Fieldservice Bulletin

Field Service Bulletin Nr. 9 for ADC Solo Type 5155

Suction cups don´t release IP

Figure 1

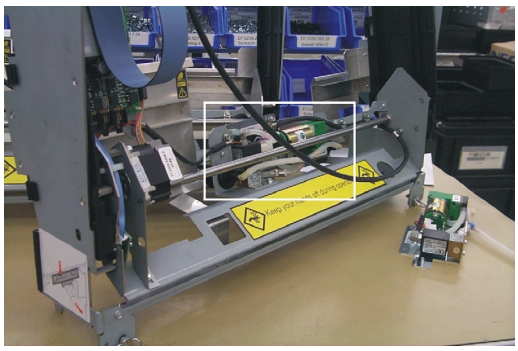
1. Open the right side panel.
2. Examine the solenoid valve of the vacuum pump in the IP-transport unit.

Figure 2

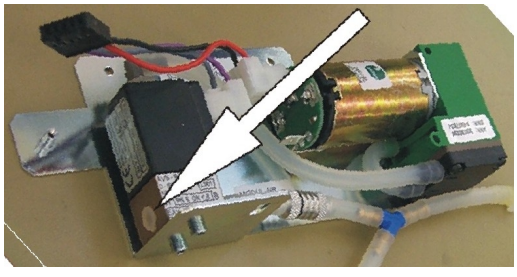
3. If the dust protection (arrow) is still on the solenoid valve, use a firm solid tool (e.g. screwdriver) to remove the plastic plug from the solenoid valve of the vacuum pump.

The dust protection can be removed permanently. It is not needed during operation.
